Overview: Production error in version 1.0 harnesses; The immobilizer wire (orange/black) is in pin position #4 instead of pin position #5. Although an effort to correct the issue was made, some quantity of harnesses did get shipped before the issue was spotted. We are advising to inspect the harness BLADE connector before attempting to install harness or program the module. This issue is not known to affect the version 2 harnesses, which require no modification.

MODIFICACIÓN REQUERIDA PARA APLICACIONES A/T, SÓLO CON ARNÉS v 1.0

FTI-STP1: Notas de preparación y cobertura del vehículo

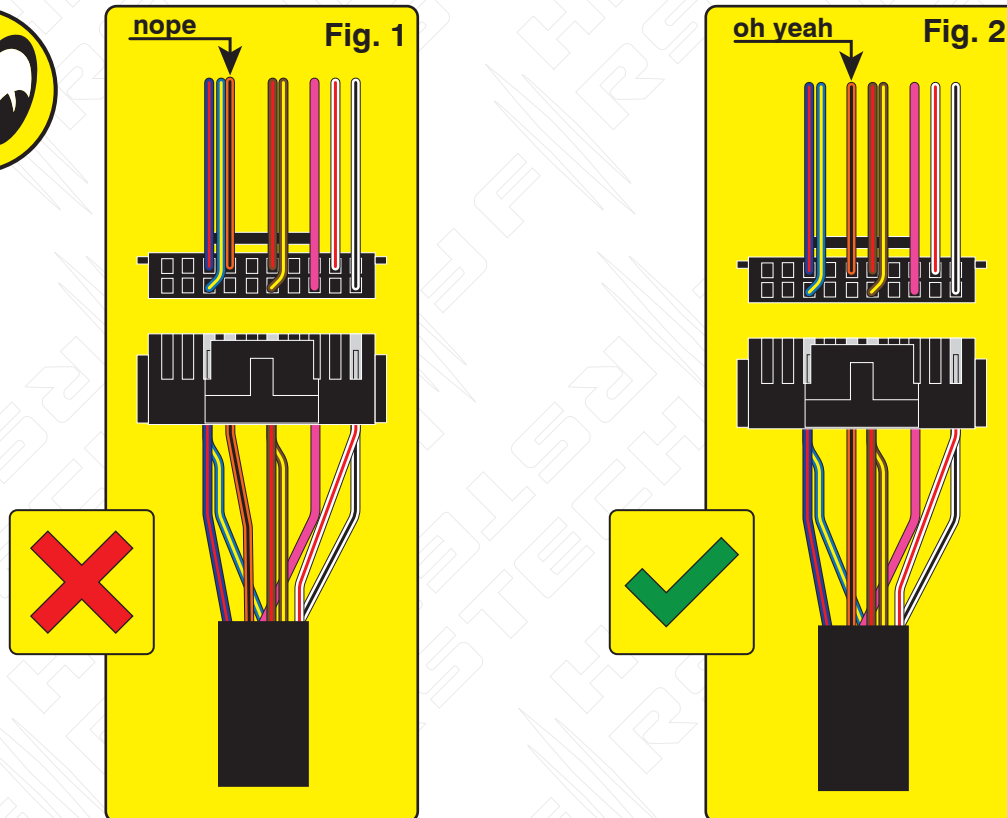
Issue: Module fails to program correctly to vehicle, does not allow the vehicle to be remote started.

Correction: Step 1.) Locate the orange/black wire and confirm whether it is positioned as illustrated in Fig. 1 or Fig. 2. If the wire is as illustrated in Fig.1, proceed with Step 2 through 5 and complete the repair procedure outlined, if the wire is as illustrated in Fig. 2, correction is not necessary, proceed with harness installation and module programming.

Step 2.) Using a pick, lightly depress the catch that secures the terminal in the housing then remove the wire and terminal from the housing.

Step 3.) Using a fine tip razor or utility knife, insert the blade beneath the terminal catch and raise it slightly, so that it can be reused to secure the terminal when reinserted into the BLADE connector housing.

Step 4.) Refer to Fig. 2 for correct position of the orange/black wire (next to brown/red) then reinsert the terminal, pressing lightly until the catch 'snaps' into place, securing the terminal in the connector housing.

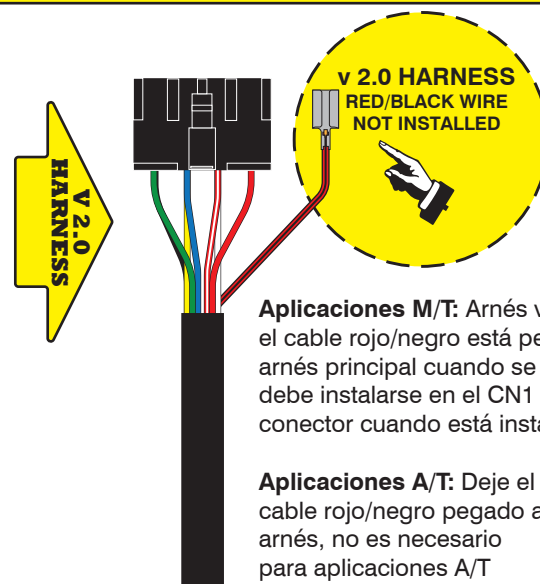
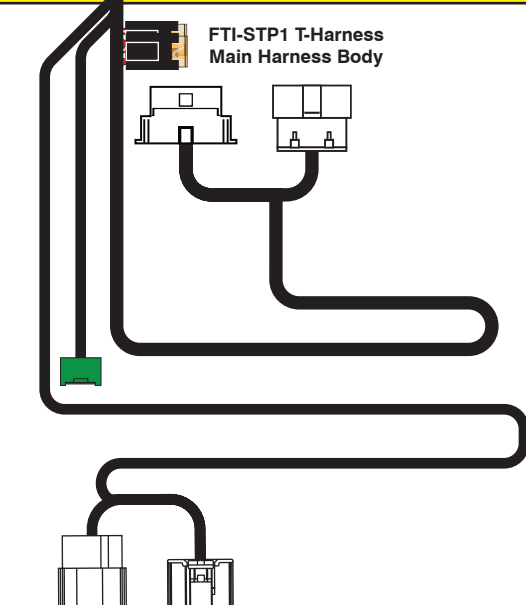
Problema: El arnés en T FTI-STP1 ha sido diseñado para ser compatible con A/T (transmisión automática) y M/T (manual), pero debido a un descuido en las primeras ejecuciones de producción, la selección se estableció por defecto en el modo M/T.

El uso de un arnés configurado para una aplicación M/T, en un vehículo equipado con A/T, podría provocar daños en el módulo del vehículo, se recomienda que el arnés vuelva al modo A/T antes de la instalación en vehículos equipados con transmisión automática.

Corrección: Localice el cable rojo/negro (+ embrague) proporcionado en el conector CN1 del conjunto del arnés principal. Corte el cable rojo/negro, ya sea al ras del conector CN1 o dejando suficiente cable expuesto para que pueda aislar y asegure los extremos del cable que quedan después del corte. Aísle cada uno de los extremos restantes del cable rojo/negro y asegúrelos para evitar cualquier posibilidad de cortocircuito. Si el cable rojo/negro ya ha sido desconectado, ninguna modificación adicional se requiere para aplicaciones A/T
